ADDENDUM NO. CC-1

Millard Public Schools
Kiewit Middle School Office/Staff Lounge Renovation
Omaha, NE
BCDM Project No. 3026-09

BCDM Architects
1015 North 98th Street, Suite 300
Omaha, Nebraska 68114

June 11, 2013

SHEET AD1-1, DEMOLITION PLAN

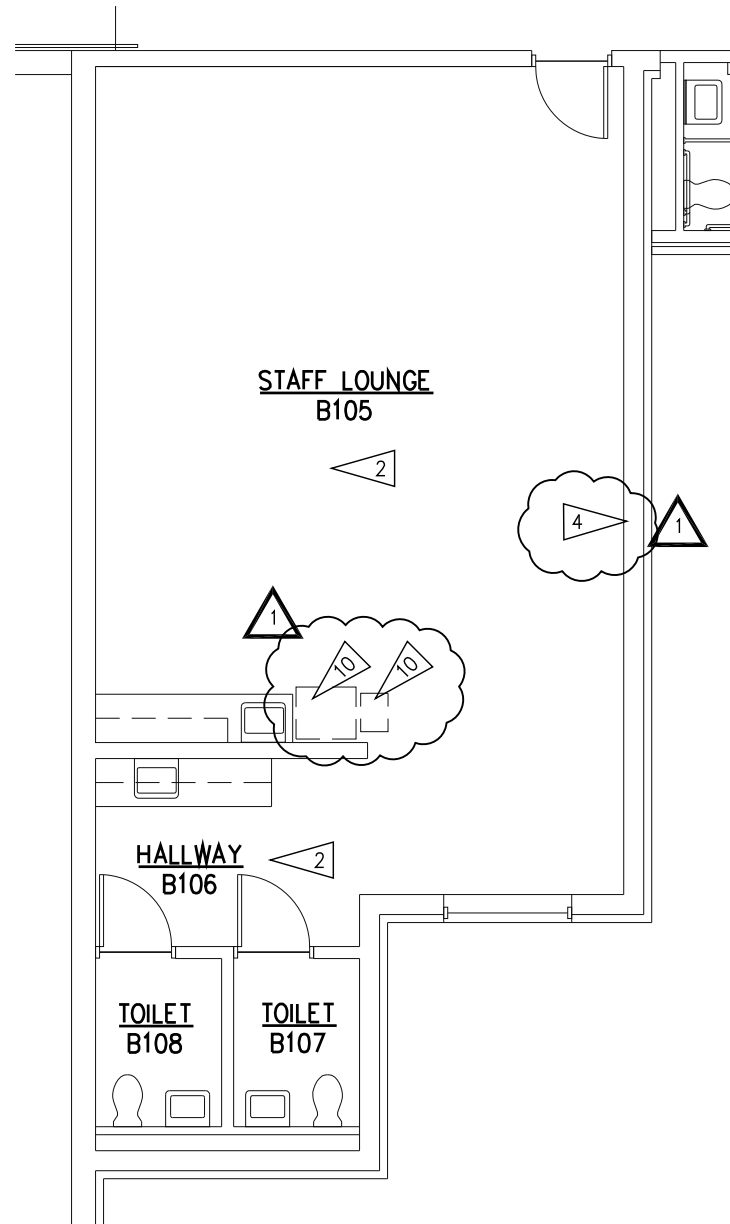
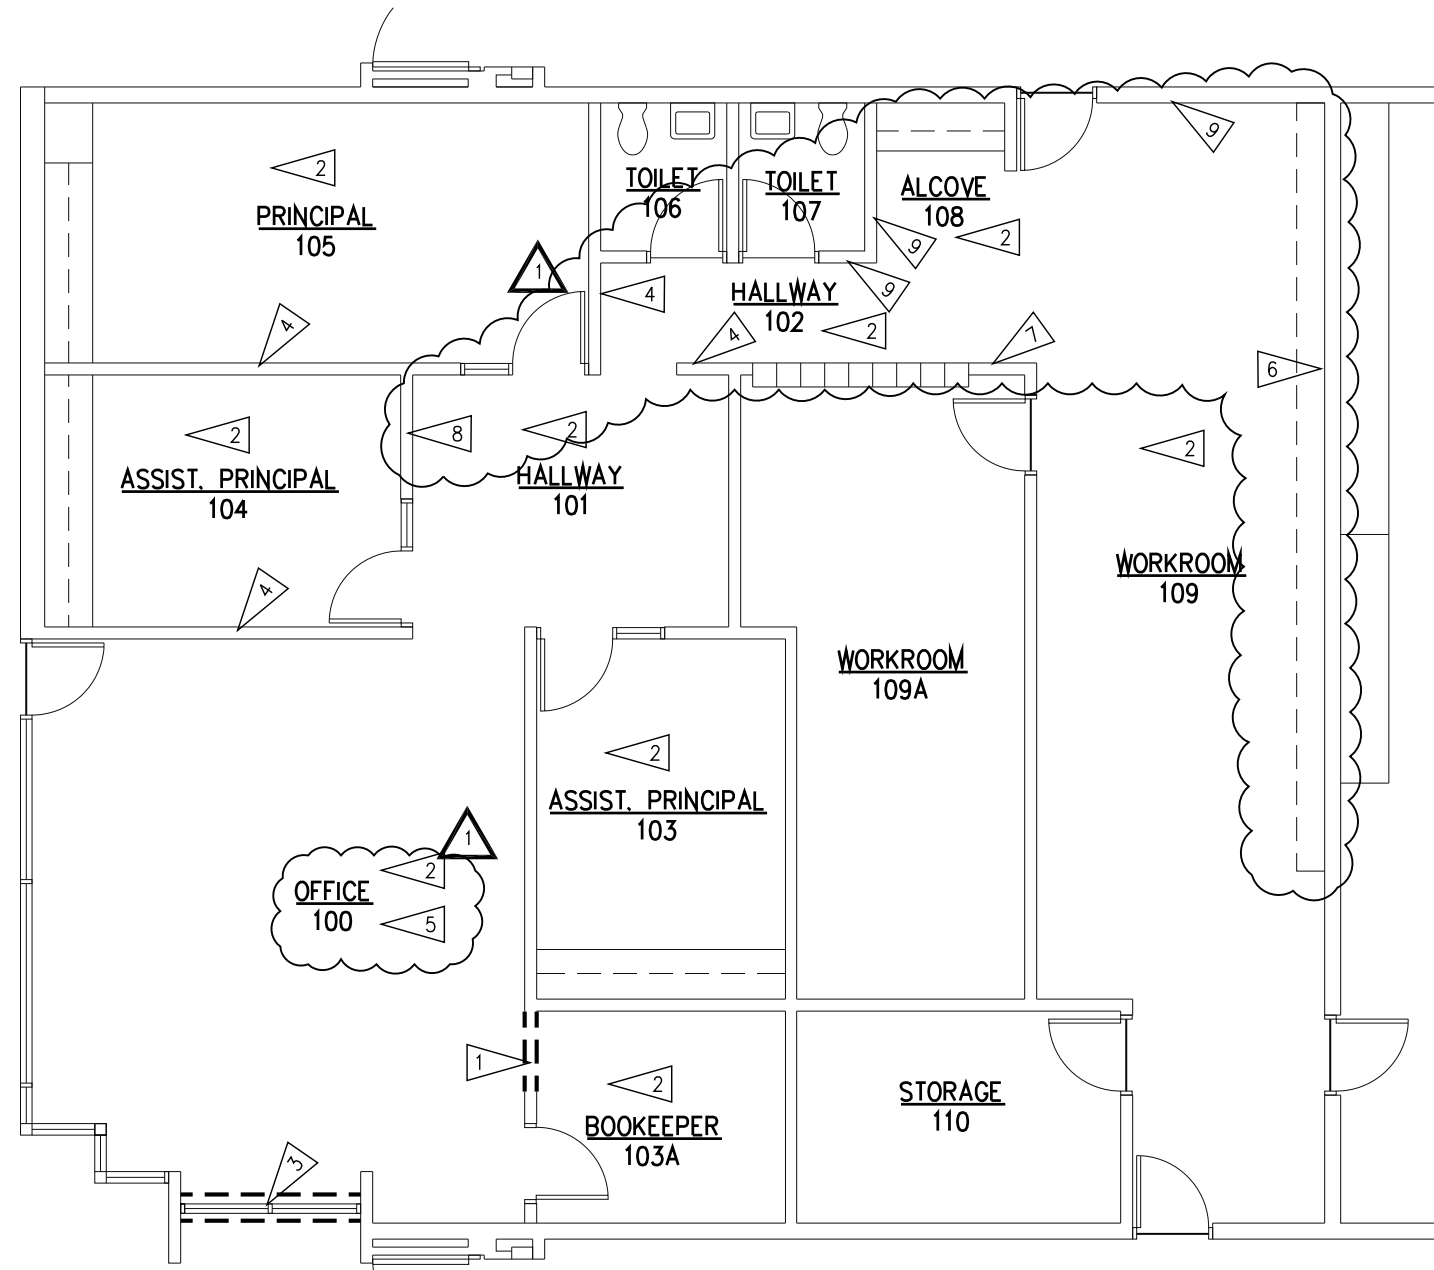
a. See attached revised demolition plan for modifications.

SHEET A1-1, FLOOR PLAN

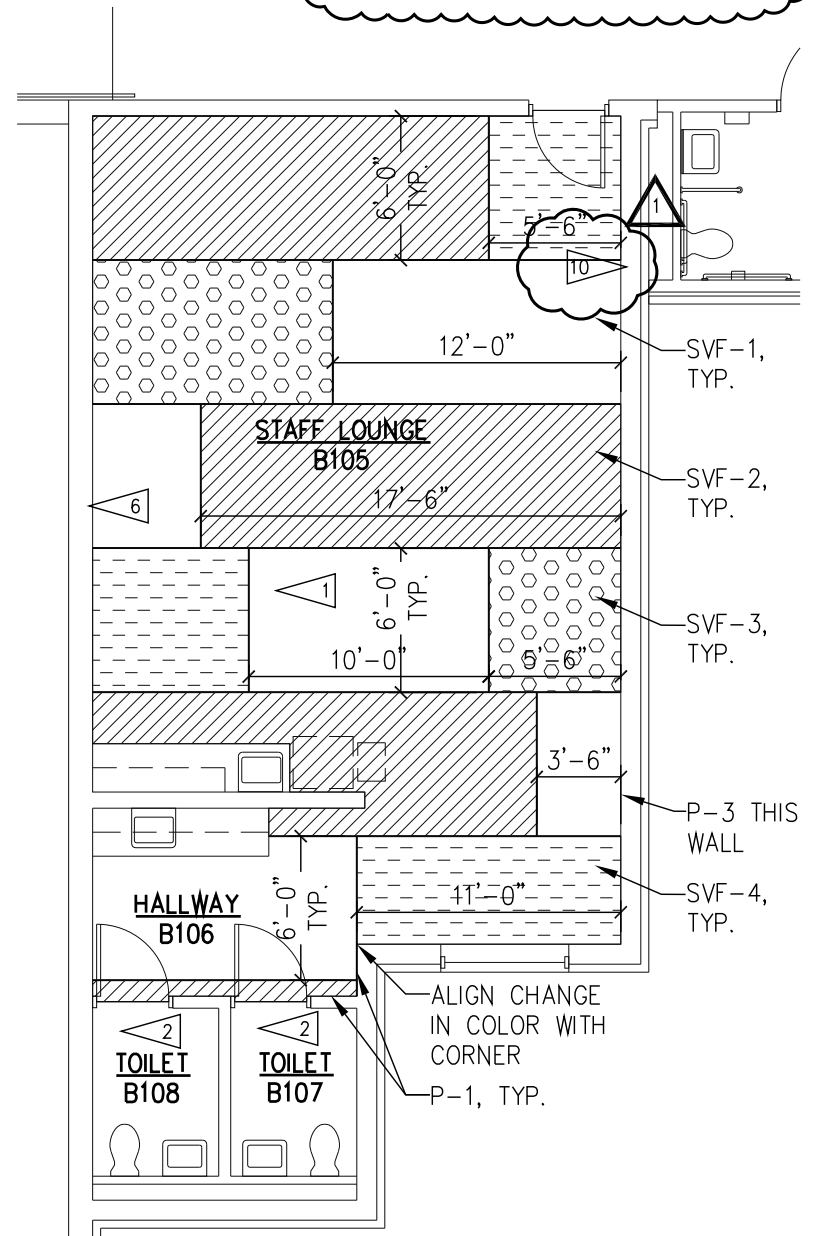
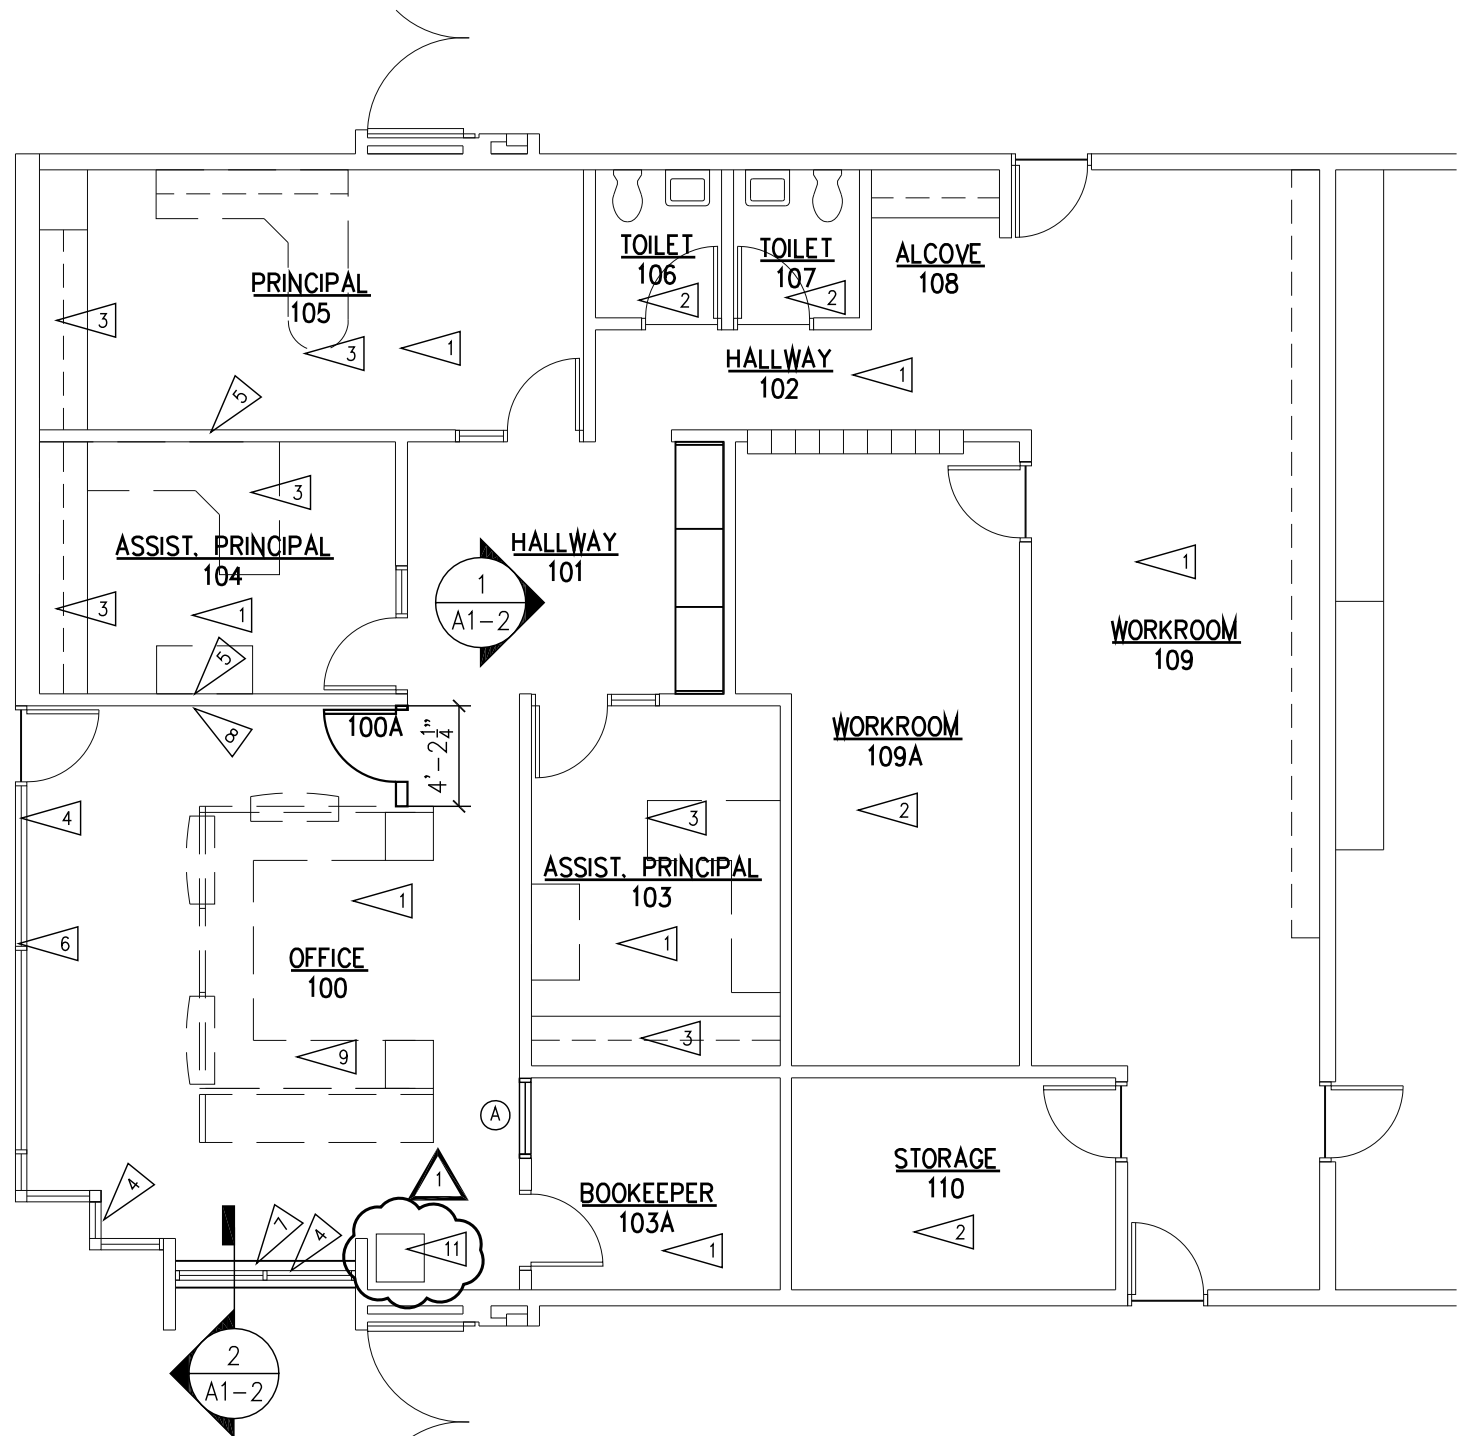
a. See attached revised floor plan for modifications.

SHEET ED1-1, ELECTRICAL DEMOLITION PLAN

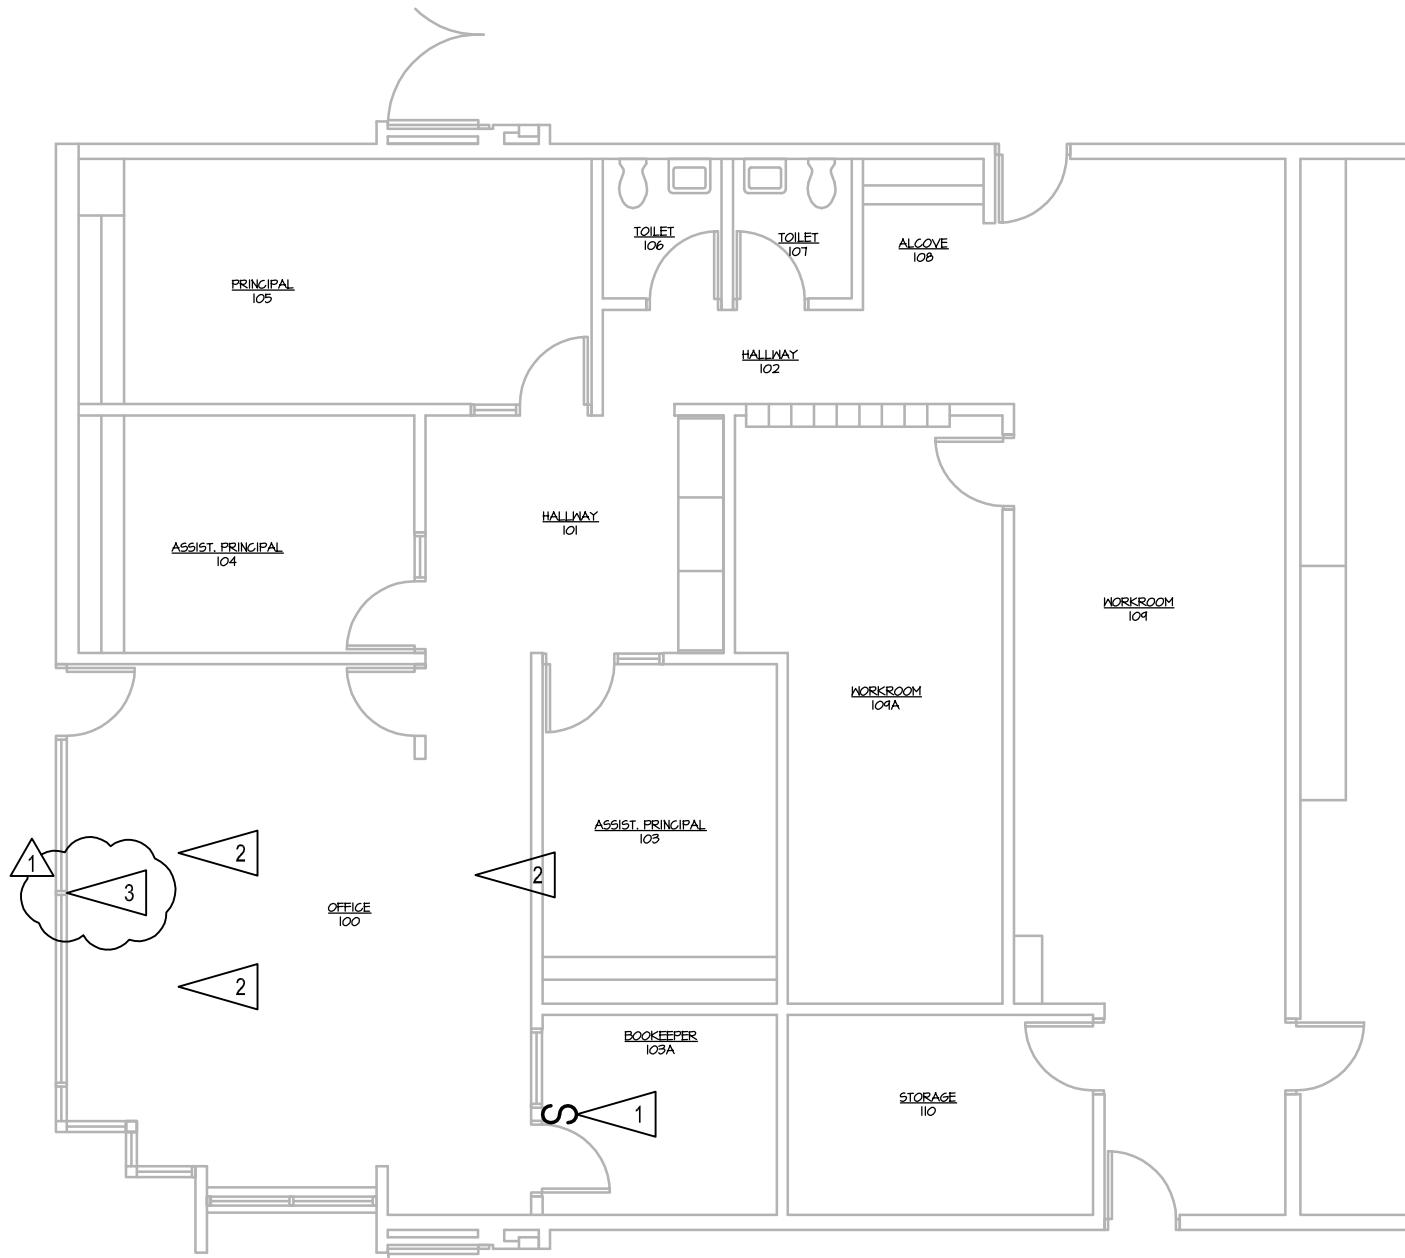
a. See attached revised electrical demolition plan for modifications

SHEET E1-1, FLOOR PLAN – OFFICE - POWER PLAN

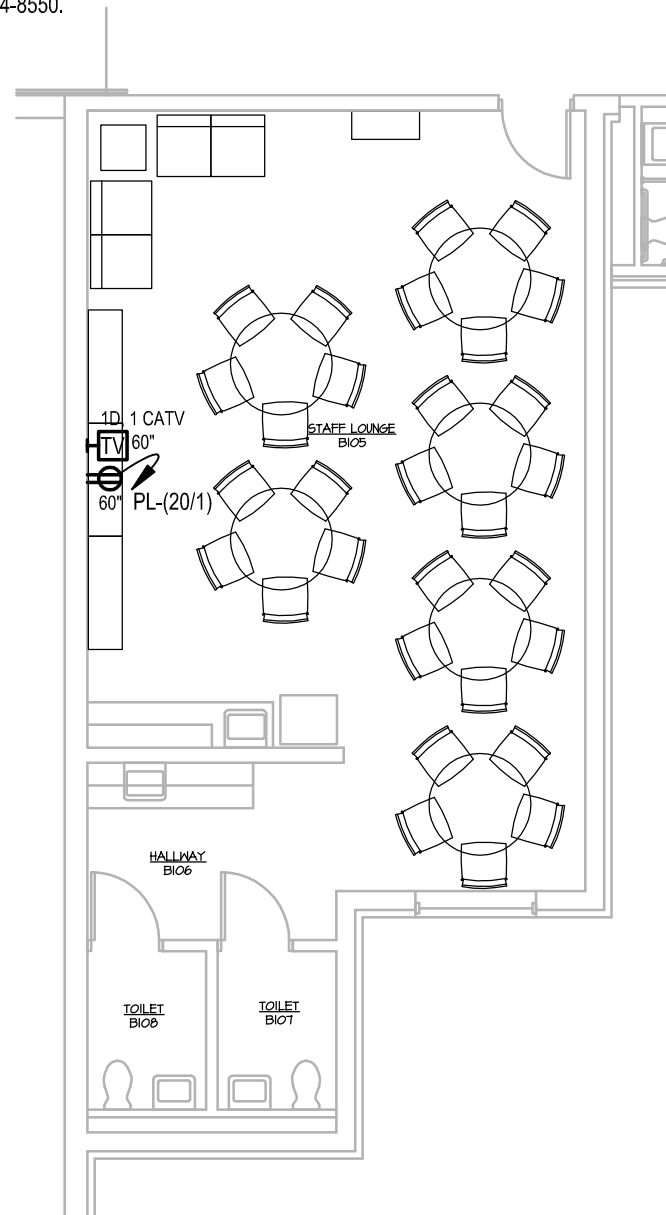
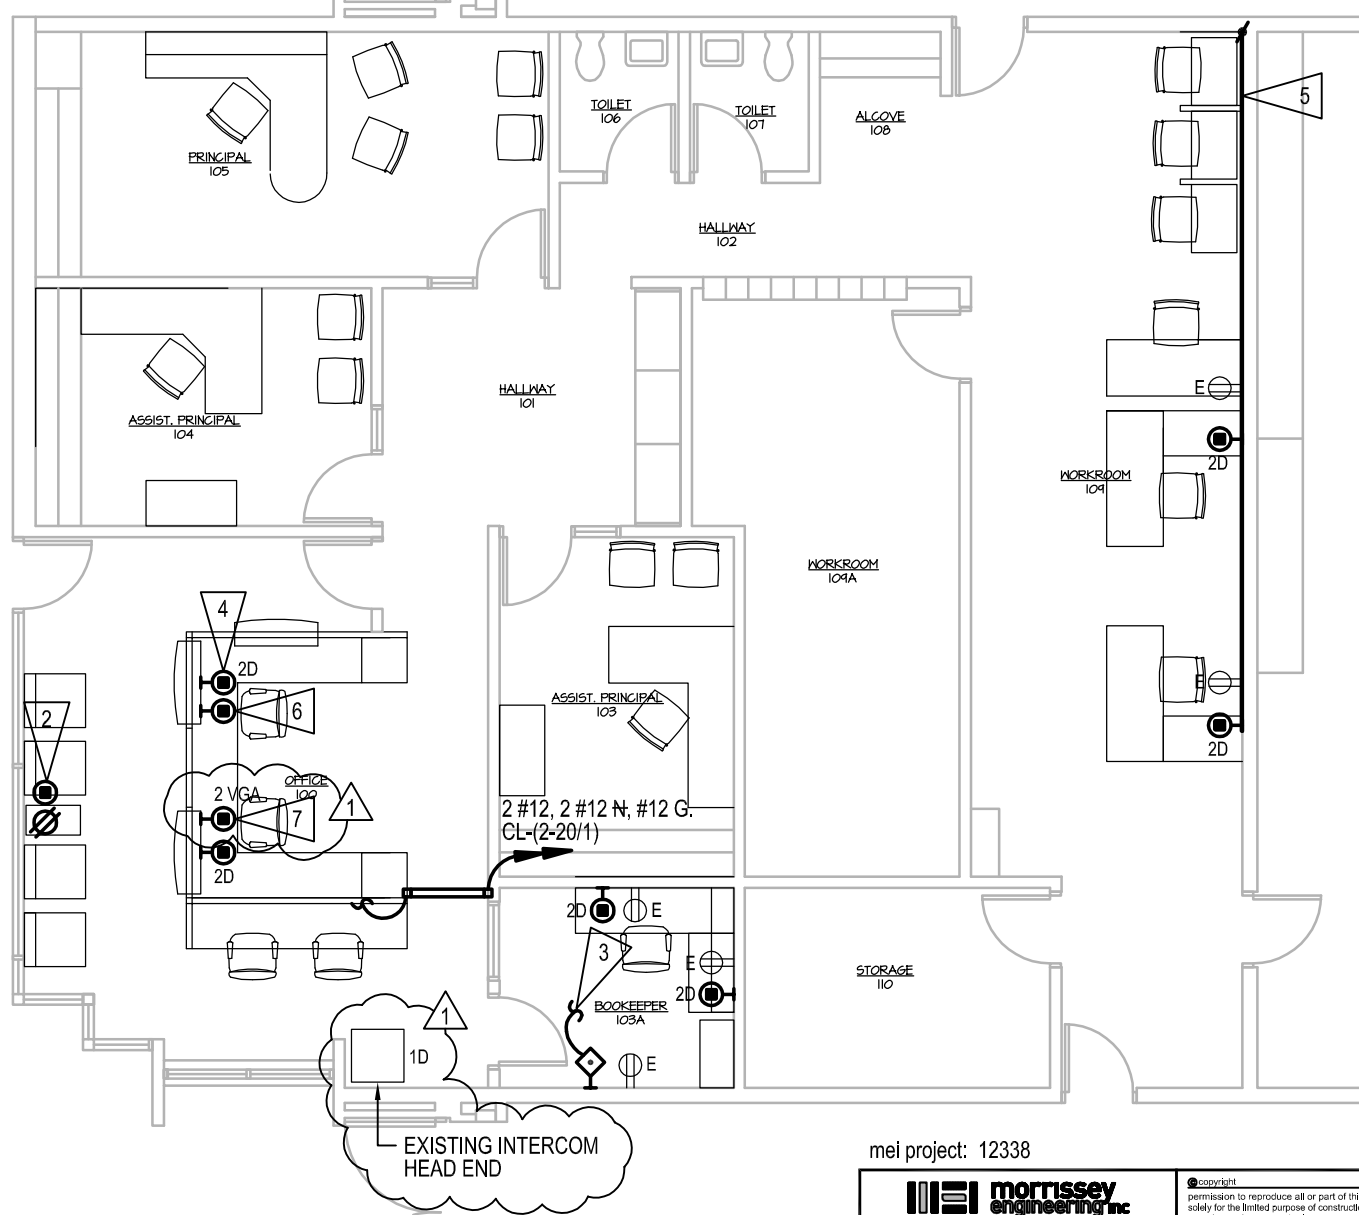
a. See attached revised power plan for modifications.
